Re: *Public Hearing Continuation Request*
 900 Washington St., MA (AKA Olam Estates)
 ASE Project No.: 2019-032

SITE PLAN MODIFICATION
505 WEST CENTRAL STREET
LOT 3
(515 WEST CENTRAL STREET)
FRANKLIN
MASSACHUSETTS
SITE PLAN

DATE: March 2, 2021
TO: Franklin Planning Board
FROM: Department of Planning and Community Development
RE: 515 West Central St
Site Plan Modification

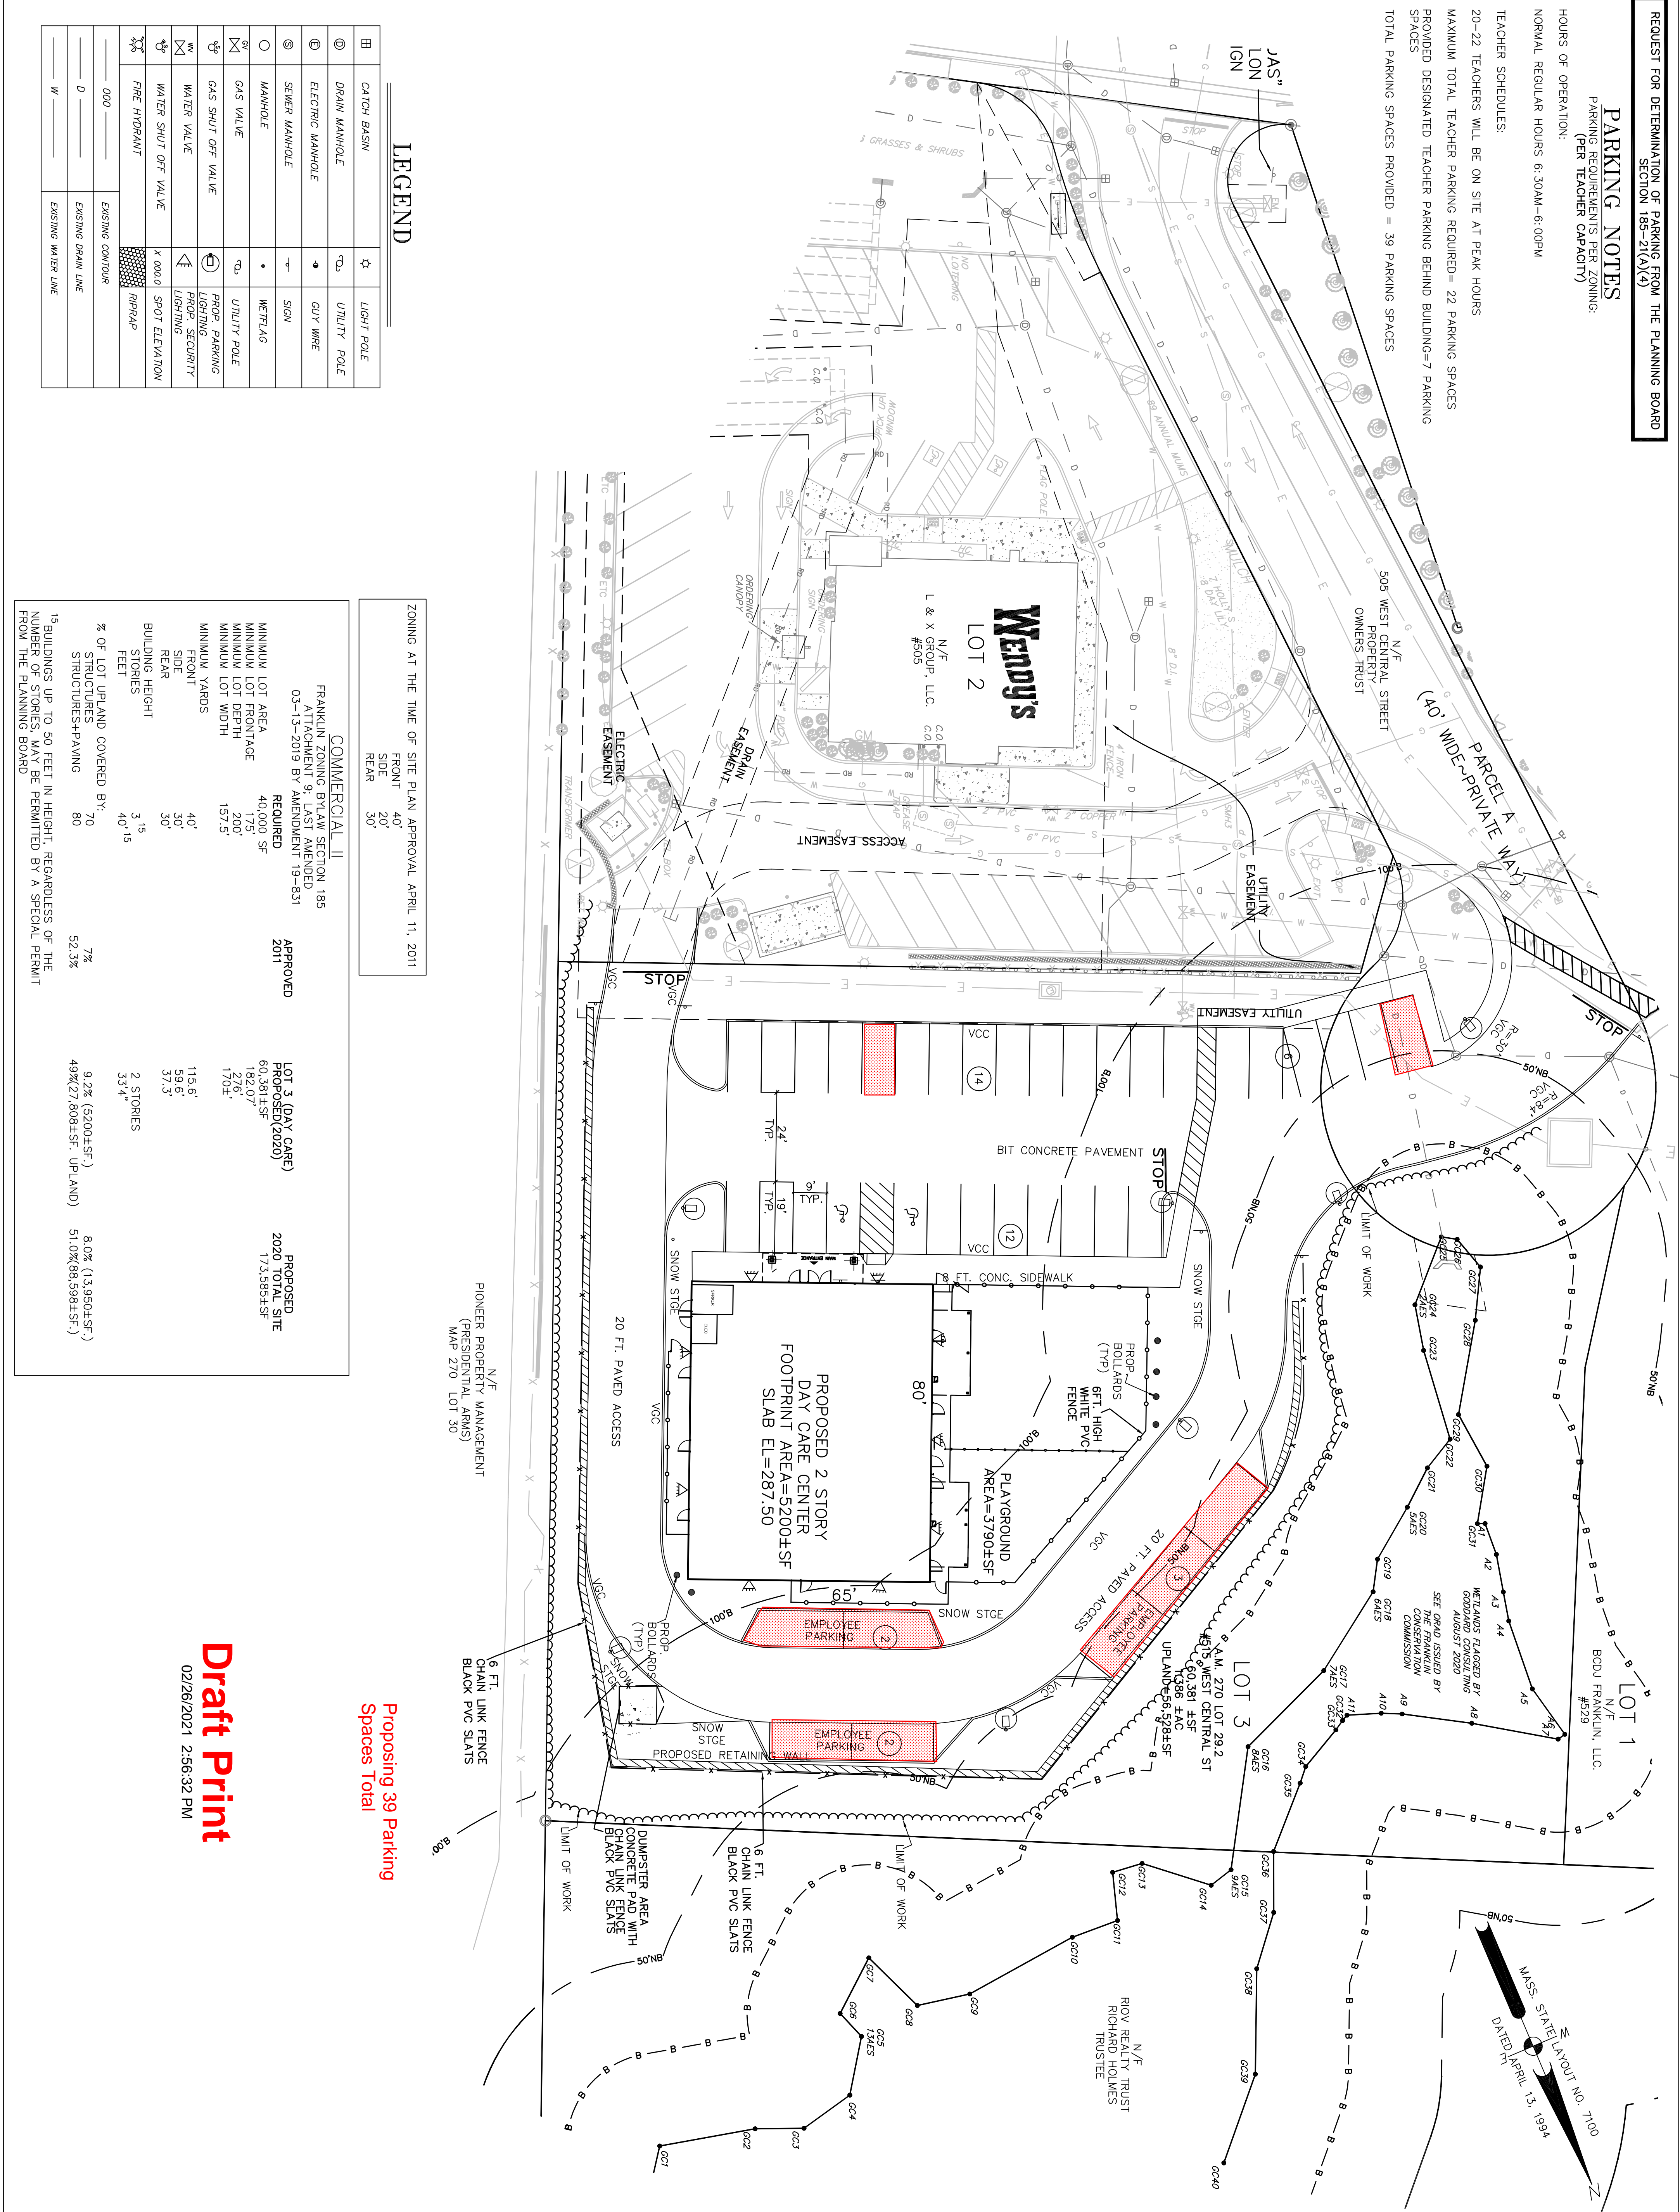
1. Applicant has submitted the following documents for the meeting:
 - Proposed Parking Schedule
2. The Planning Board discussed at the last meeting adding 20 parking spaces or reduce the size of the building.
3. The Applicant has increased the parking spaces from 30 to 39.

Proposing 39 Parking Spaces Total

DATE	REVISION DESCRIPTION
12/22/2020	PER TOWN COMMENTS
2/23/21	revised parking
